A D D E N D U M

Project Title: Carleton – Sewell Parking Garage	Addendum No: 5
Tender No: 2010-081209T	Date: December 8, 2010

ARCHITECTURAL AND STRUCTURAL ADDENDUM NO. 2

Date Issued: December 7, 2010
Issued By: Scott Wallace, P.Eng. (RJC)
Colin Turner, AANB (ADI)

Project Title	
SEWELL-CARLETON PARKING GARAGE	
Dwg. Title	
REVISED PARTIAL SOUTH ELEVATION	
Project No.	L49210111
Dwg. No.	A303SK-01
Rev. No.	0
Scale	1:100
This drawing is not to be scaled

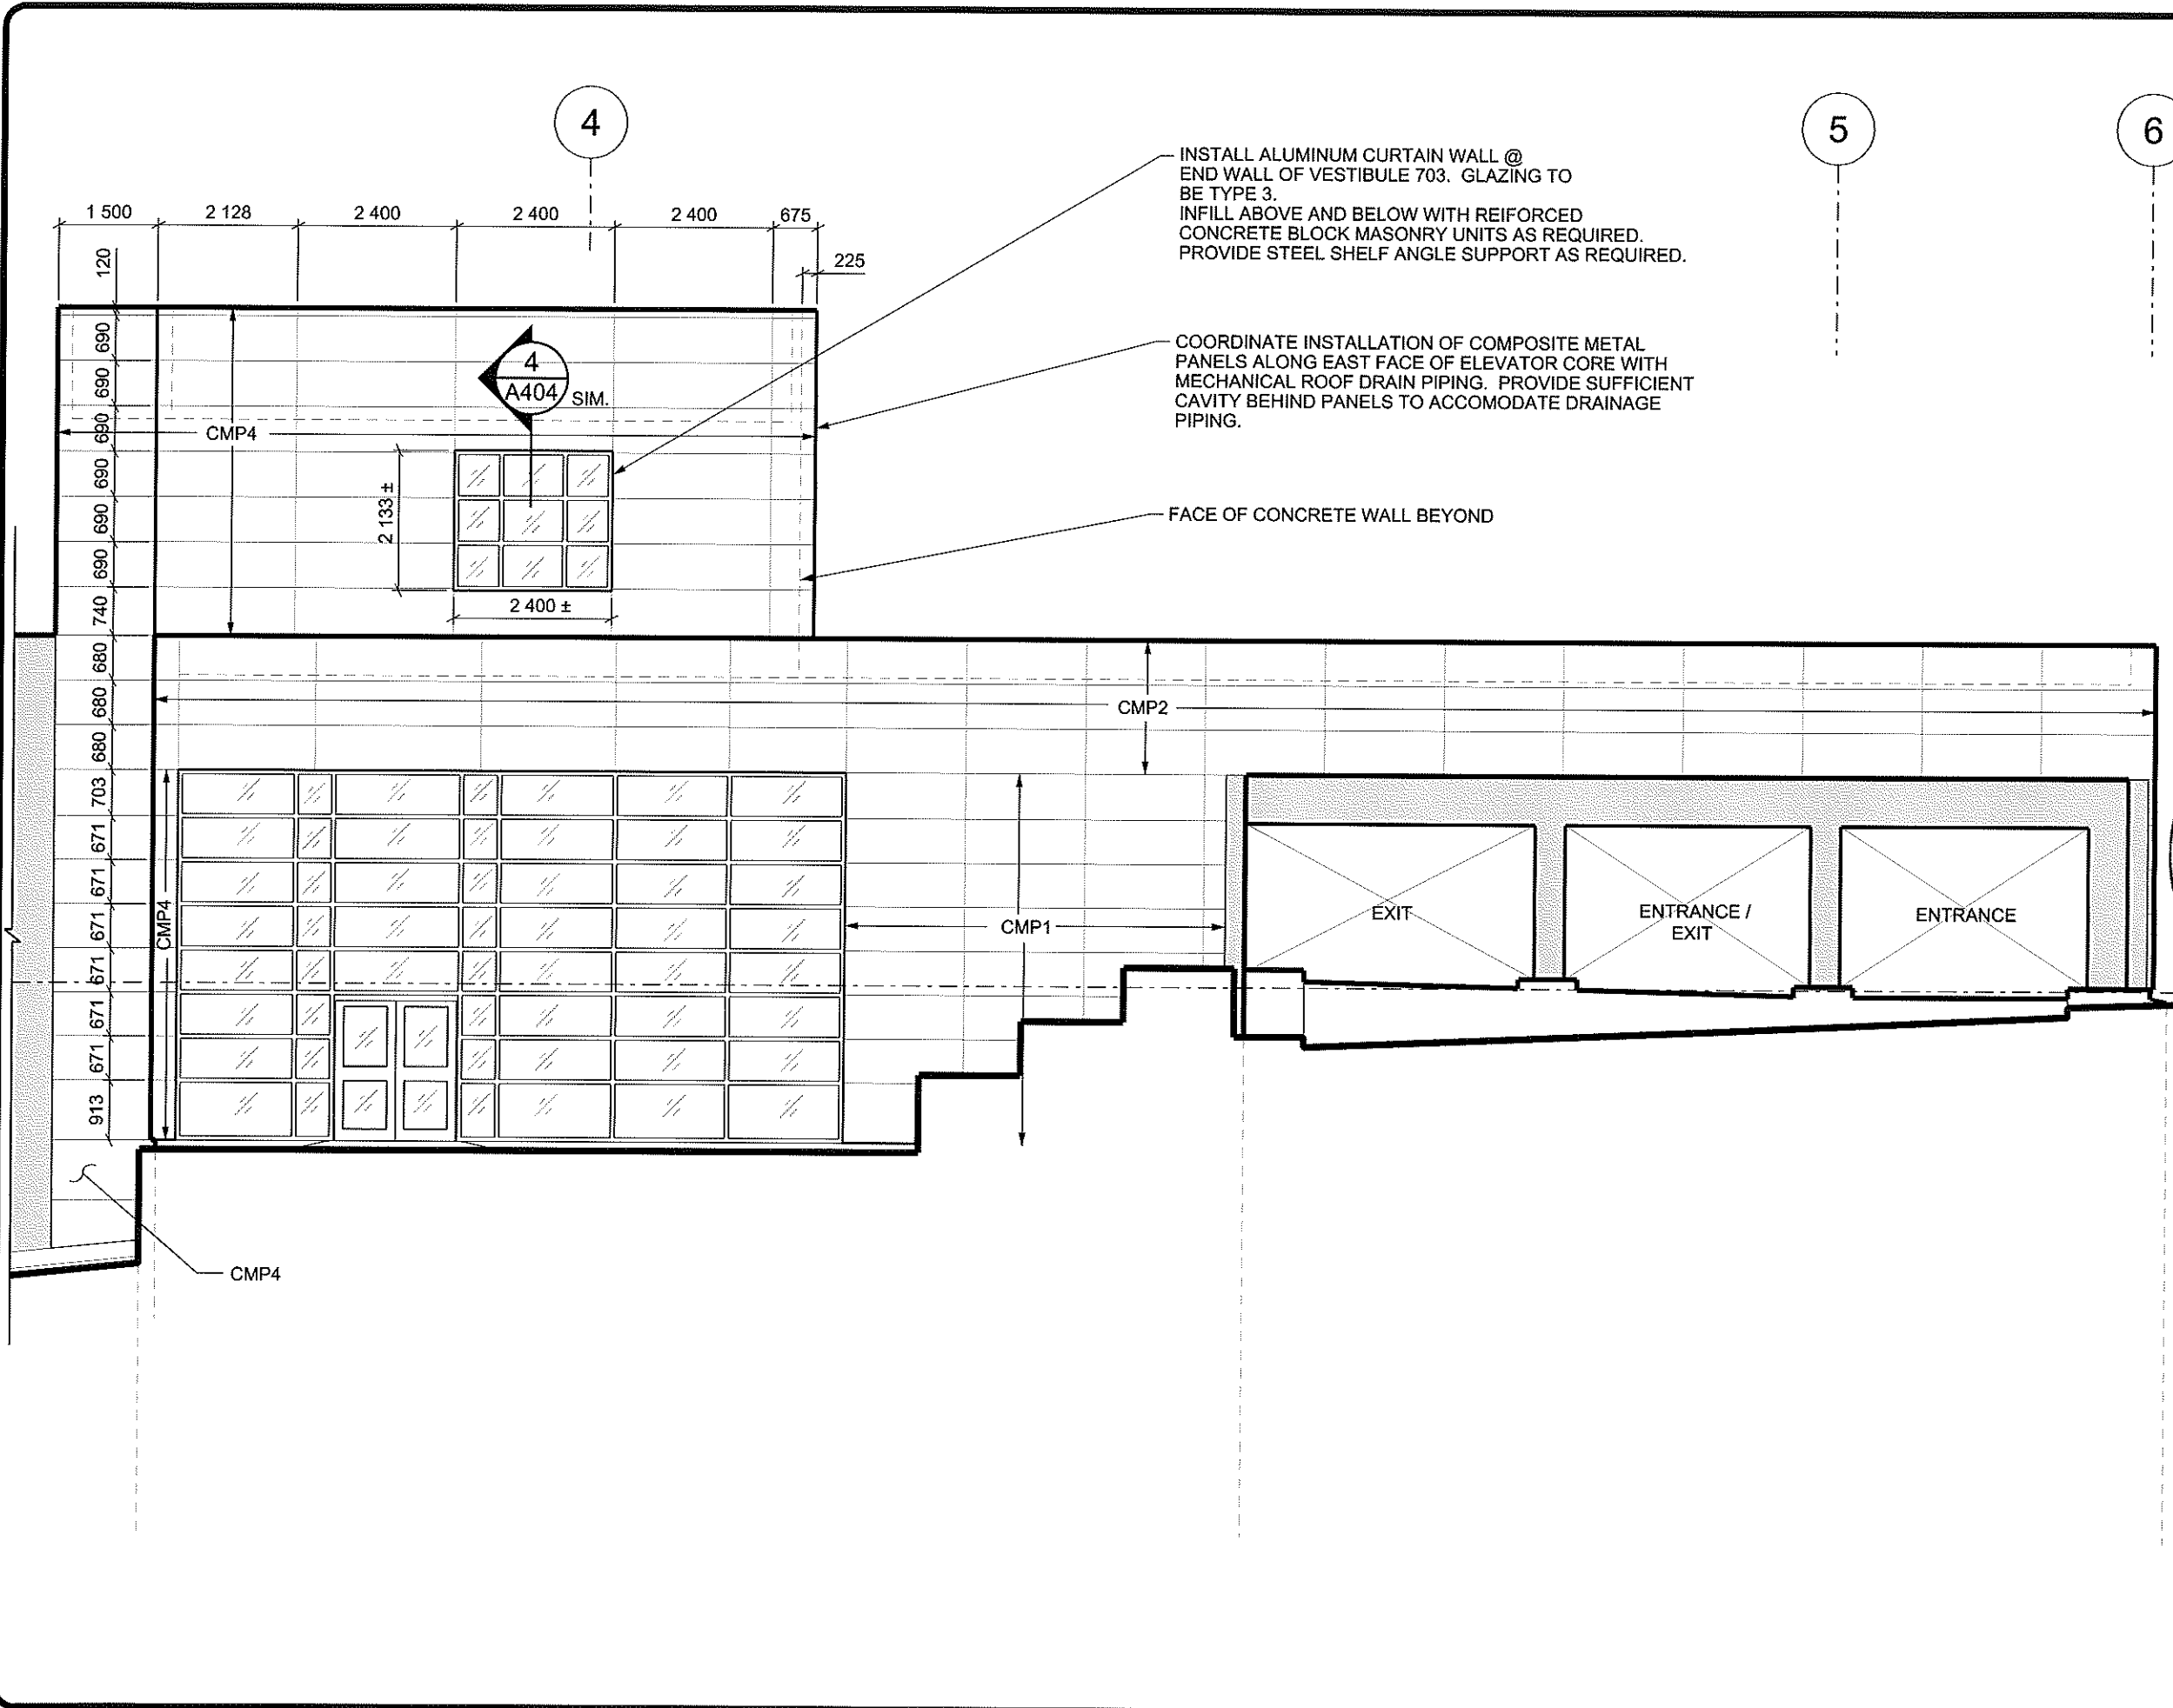
- .1 Revise Level P6 and Level P7 elevations to read “33.00 and 36.50” respectively.
- .2 Increase height of precast concrete parapet wall between grid line “1” and step in wall approximately mid way between grid lines “2” and “3” by 470mm.
- .3 Increase height of precast concrete parapet wall between grid line “6” and immediate right of the elevator core by 90mm.
- .4 Detail 1/A303: revise South Elevation to the right of grid line “3” per new Drawing A303SK-01 attached.

Dwg. Title
**DETAIL - TYPICAL FLASHING
@ GRADE**

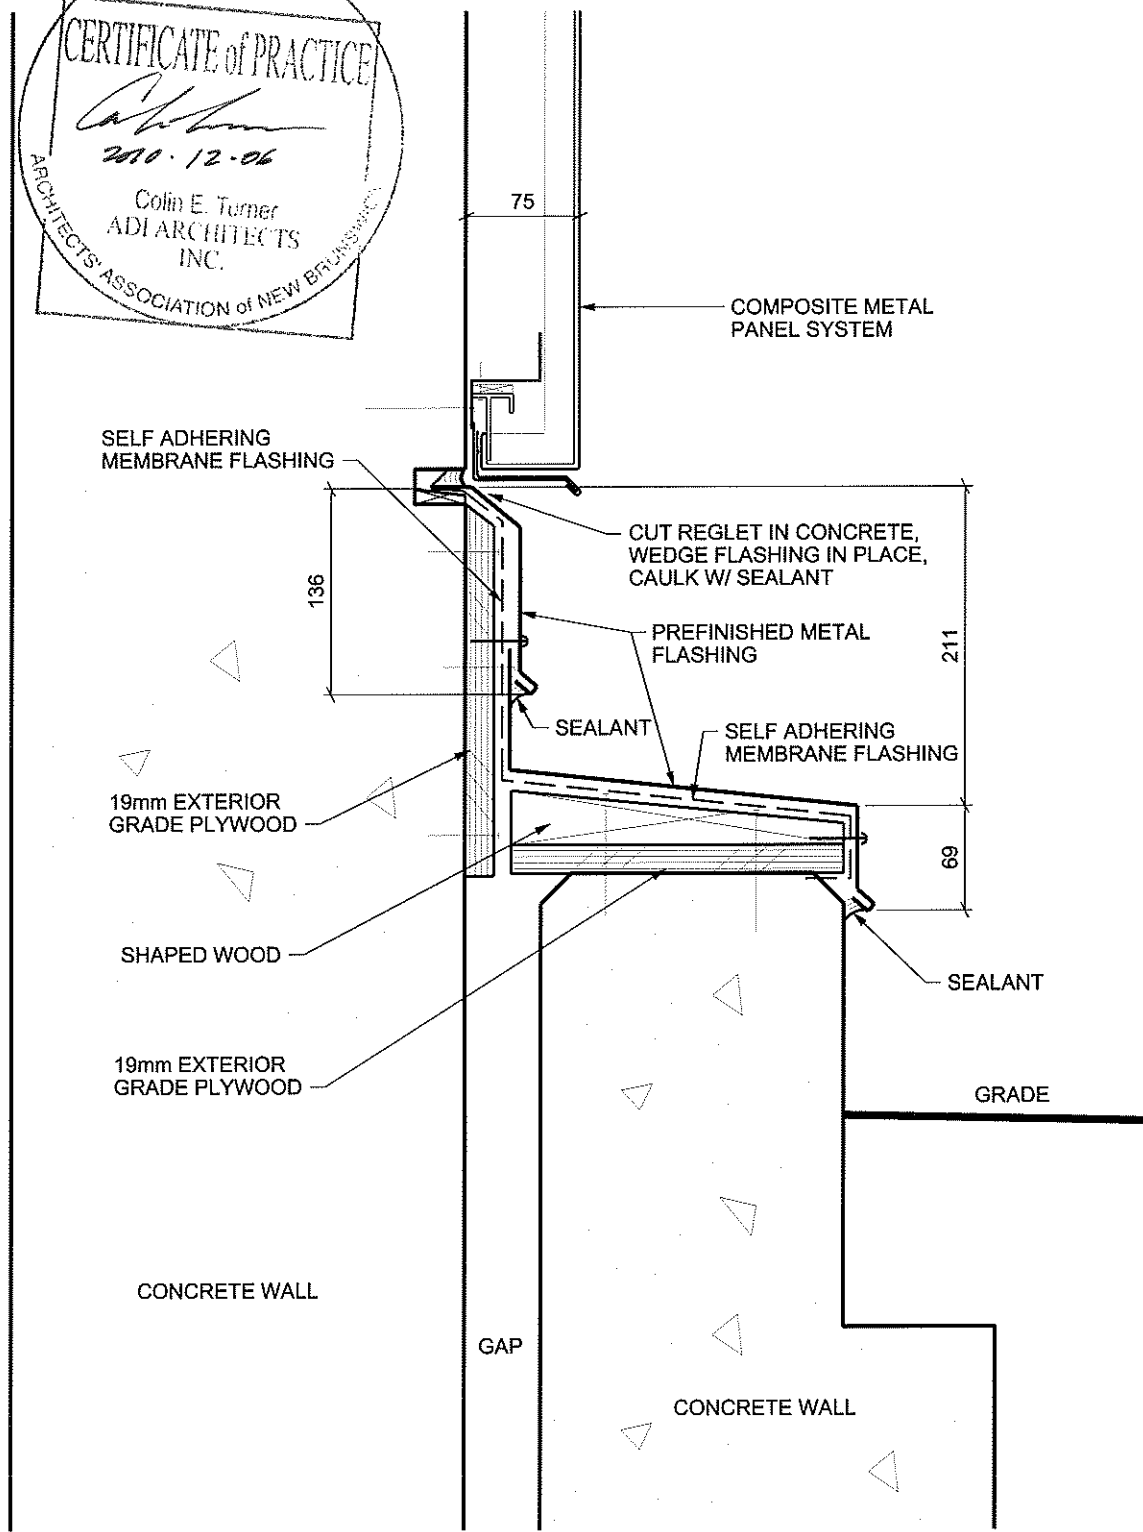
- .1 Provide structural metal framing in accordance with new Section 05410 attached.
- .2 Provide "fire seal base flashing" at all roof associated exposed wood in accordance with Section 07520.
- .3 Detail 1/A403: provide as per new Drawing A403SK-01 attached.
- .4 Detail 9/A403: provide as per new Drawing A403SK-02 attached.
- .5 Detail 10/A403: provide as per new Drawing A403SK-03 attached.
- .6 Detail 12/A403: provide as per new Drawing A403SK-04 attached.
- .7 Detail 13/A403: provide as per new Drawing A403SK-05 attached.

DETAIL - ROOF / CURTAIN WALL @ LEVEL 5 LOBBY

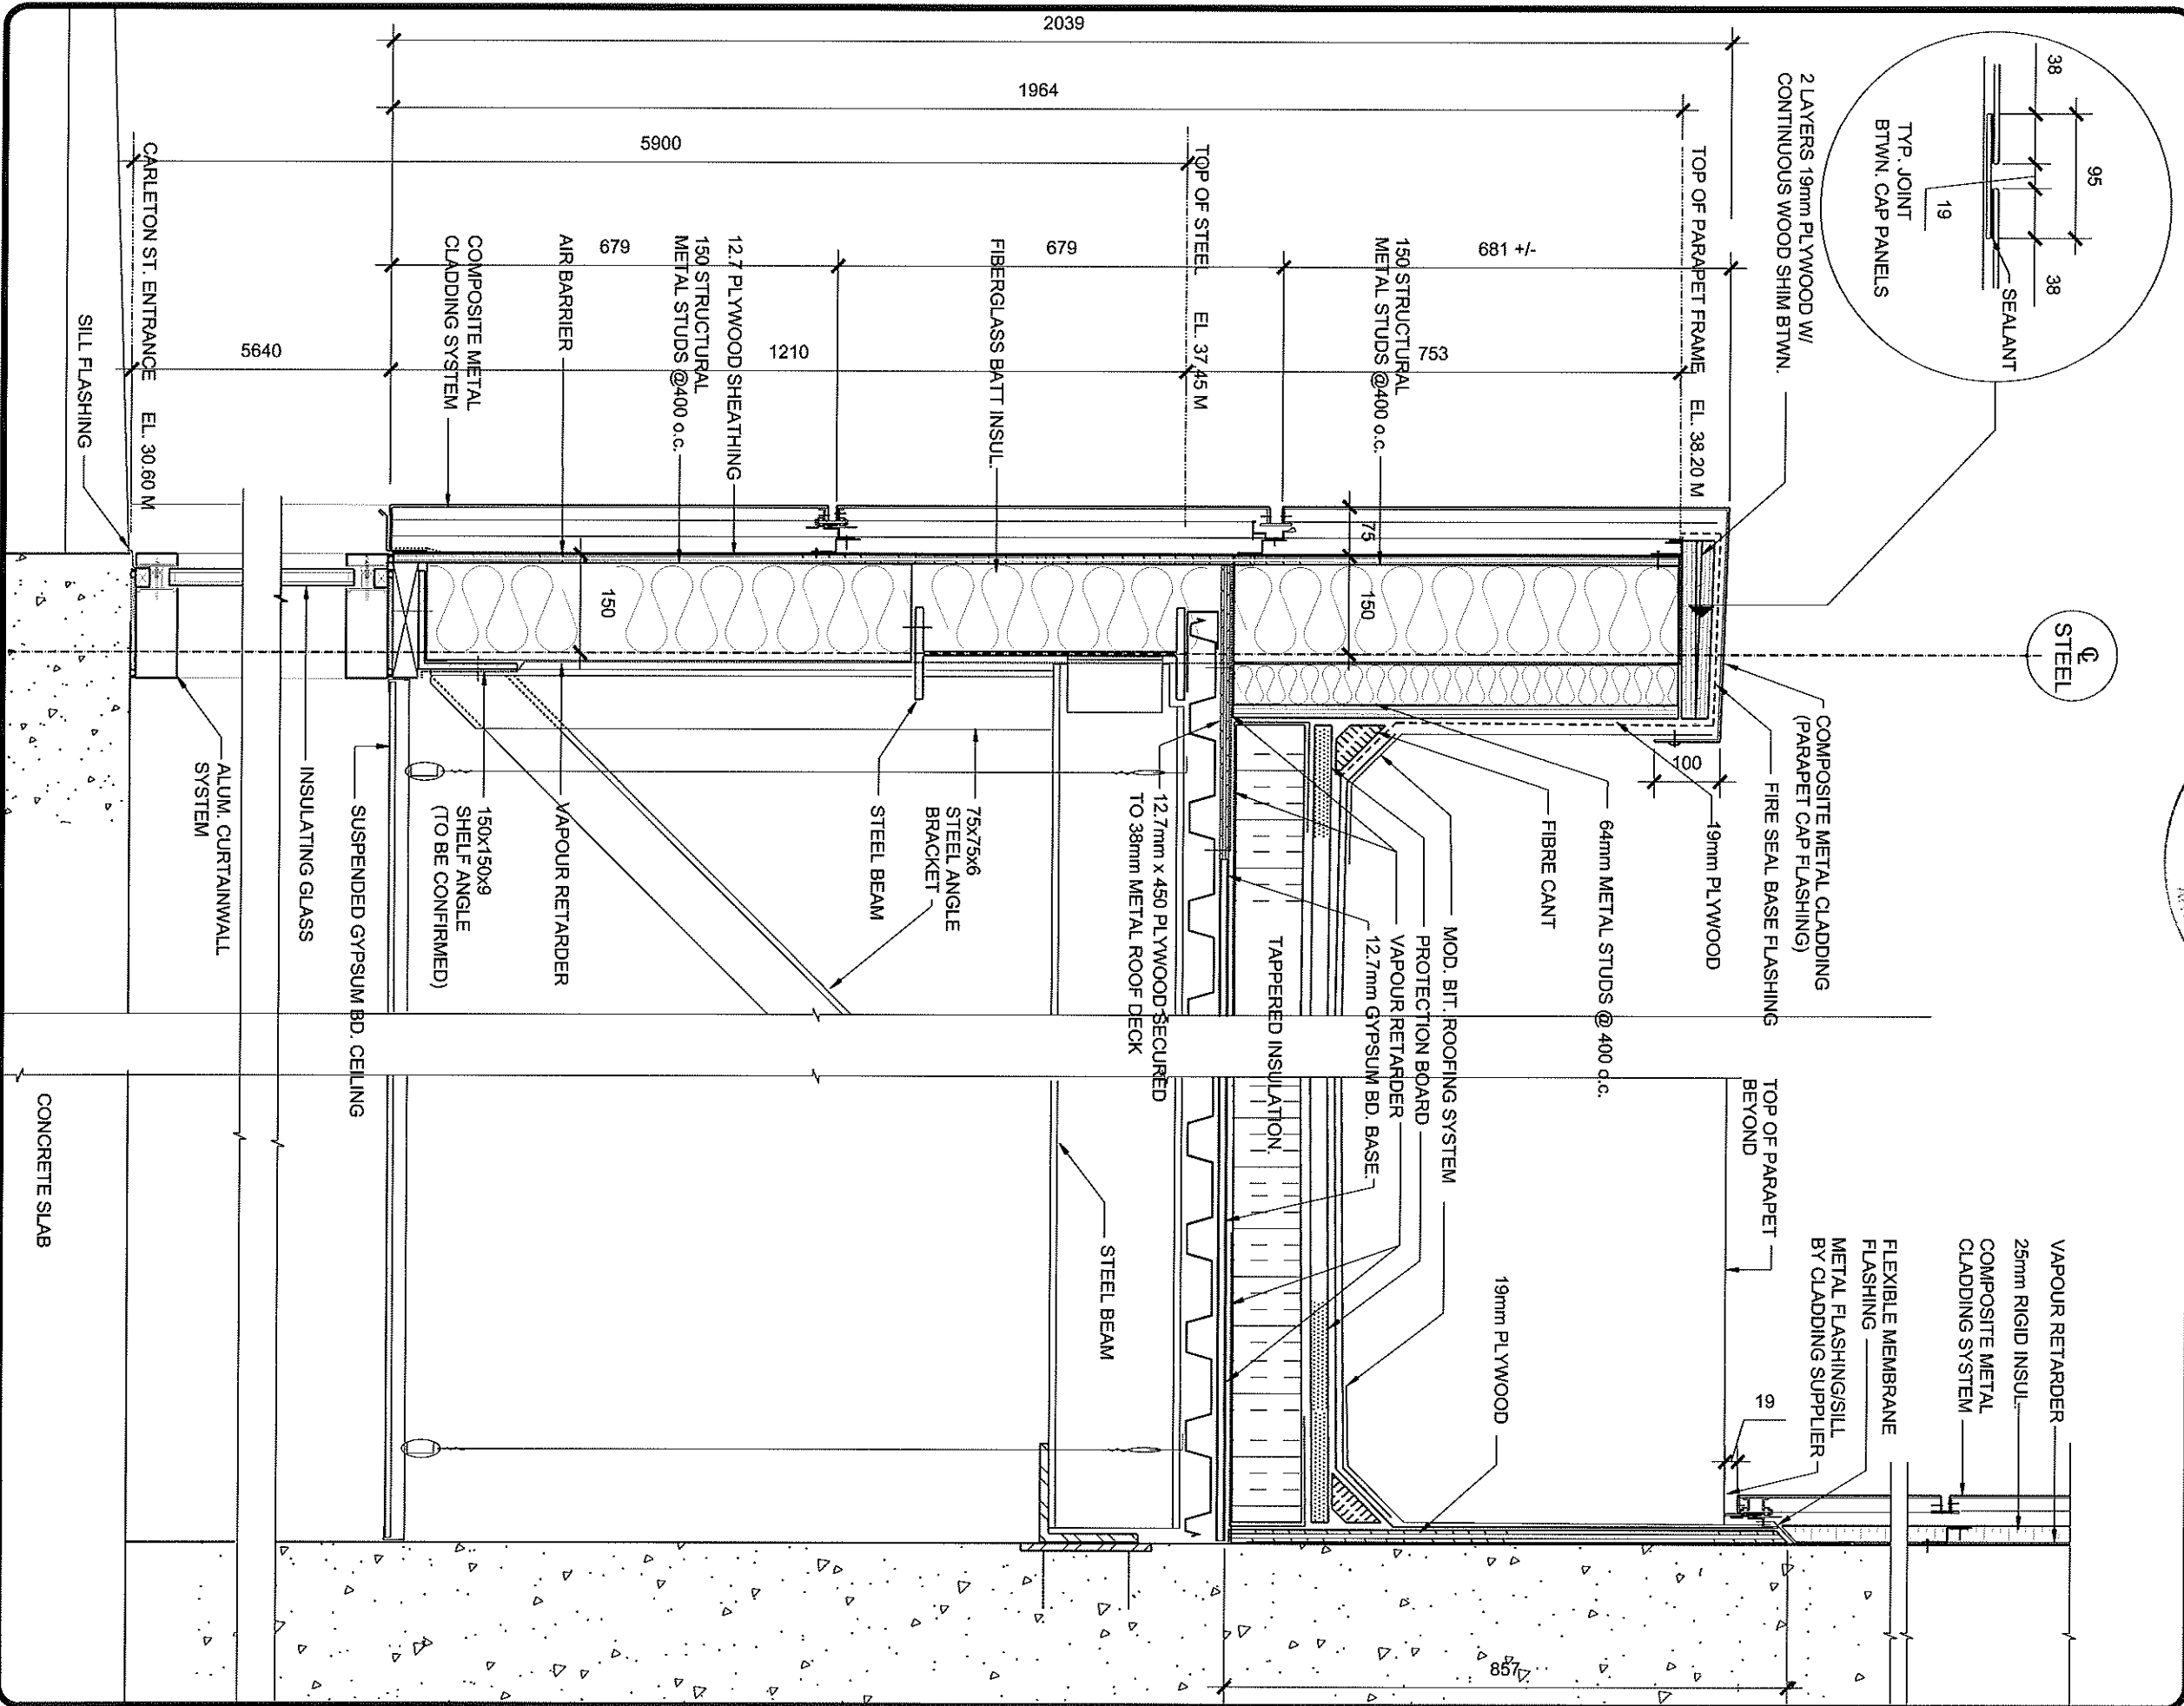
- .1 Provide structural metal framing in accordance with new Section 05410 attached.
- .2 Provide "fire seal base flashing" at all roof associated exposed wood in accordance with Section 07520.
- .3 Details 2/A404, 3/A404: insulate around penetrations through roof deck and around roof drains with "sprayed insulation" in accordance with Section 07219.
- .4 Detail 4/A404: provide as per new Drawing A404SK-01 attached.
- .5 Detail 5/A404: provide as per new Drawing A404SK-02 attached.
- .6 Detail 8/A404: provide as per new Drawing A404SK-03 attached.
